Planning Commission Meeting

4.I. 3309-3345 Dogwood Drive Preliminary Plat Review

4.II. 3309-3345 Dogwood Drive Site Plan Review

As requested, I have reviewed the preliminary plat for the 3335 Dogwood Drive multi-family site to be located on a total of 2.98 acres on the west side of Dogwood Drive, within a U-V and V Zoning District. This review is for compliance with the preliminary plat requirements of Chapter 90 of the City ordinances. The re-submittal was received on August 10, 2022. The plans were prepared by Lowery & Associates Land Surveying, LLC, under the Land Surveyor seal of Mitchell Lowery. With reference to my letter dated July 28, 2022, my comments are as follows:

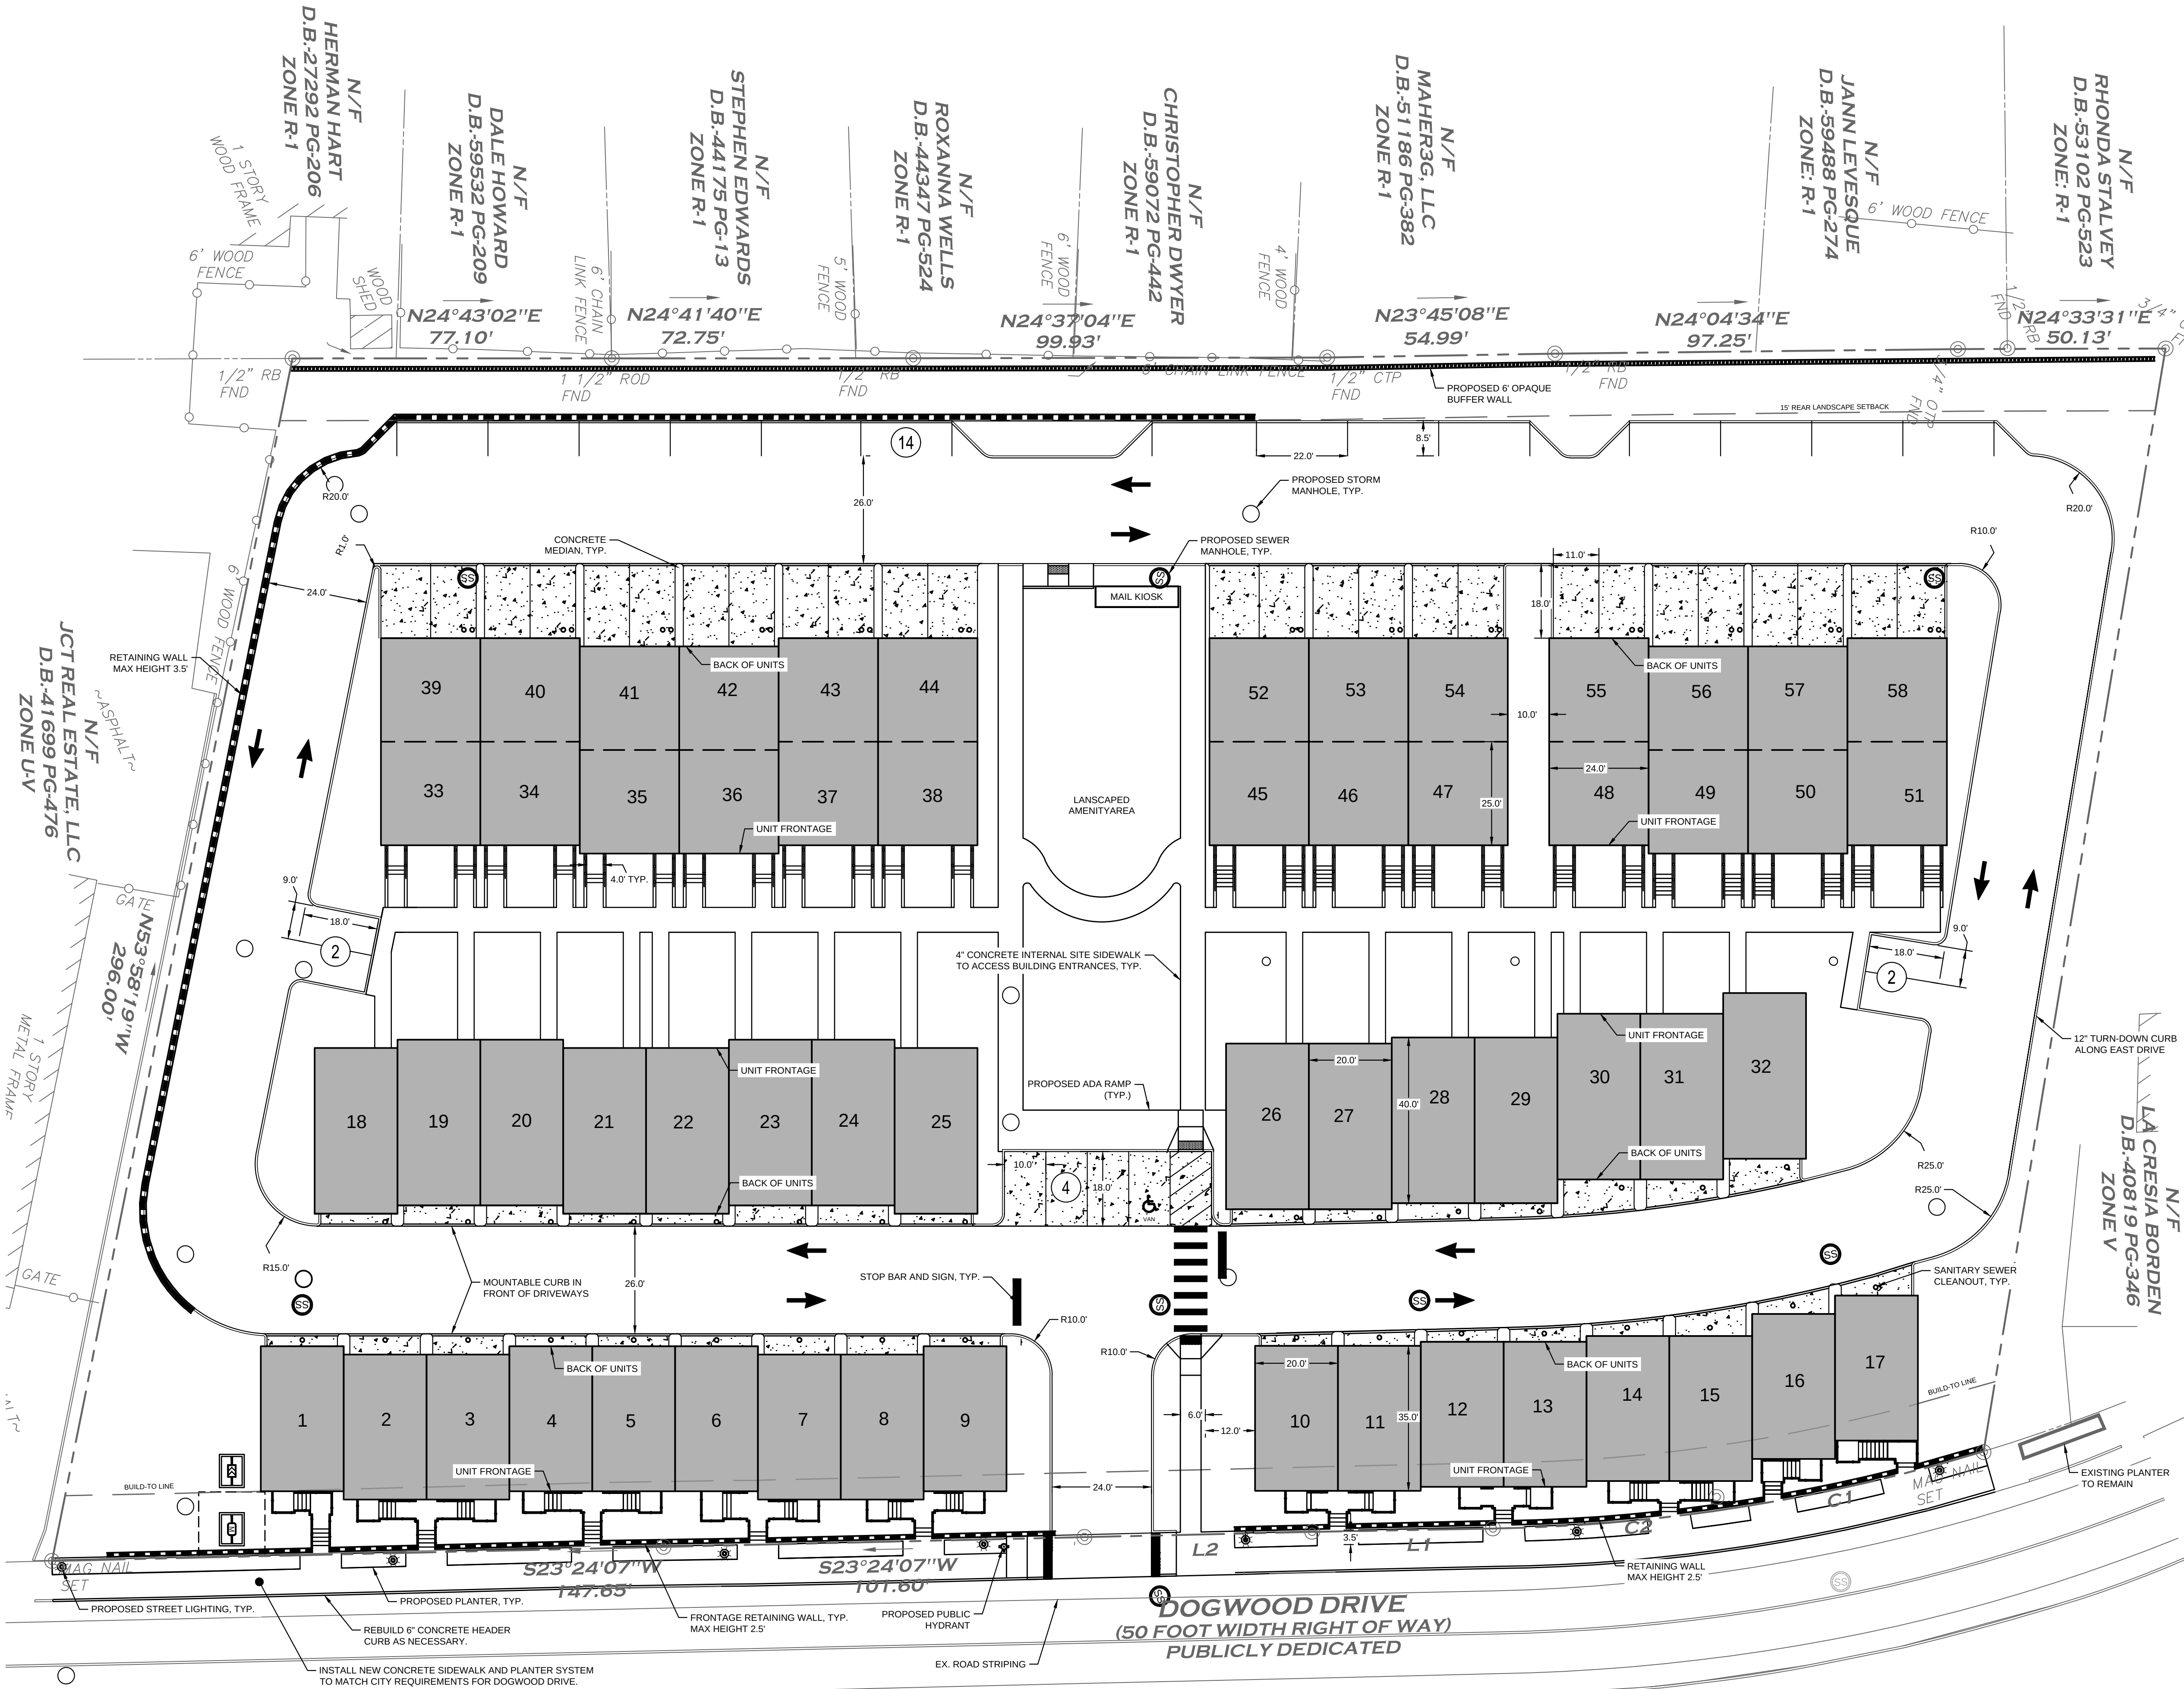
13. Comment can be considered addressed if the project narrative on sheet C0.00 and the development summary on sheet C2.00 is sufficient for the City.
14. Comment can be considered addressed if the new storm drain piping routing is addressed in the detailed plans submitted for LDA permitting.
15. Comment can be considered addressed if the remaining issues on the arborist report and final landmark tree data is addressed in the detailed plans submitted for LDA permitting.
16. Comment can be addressed in the detailed plans submitted for LDA permitting.
17. While this submittal review is for concept site plan approval only, the applicant should be aware that submittal and review of detailed site construction drawings will still be necessary prior to land development permitting.
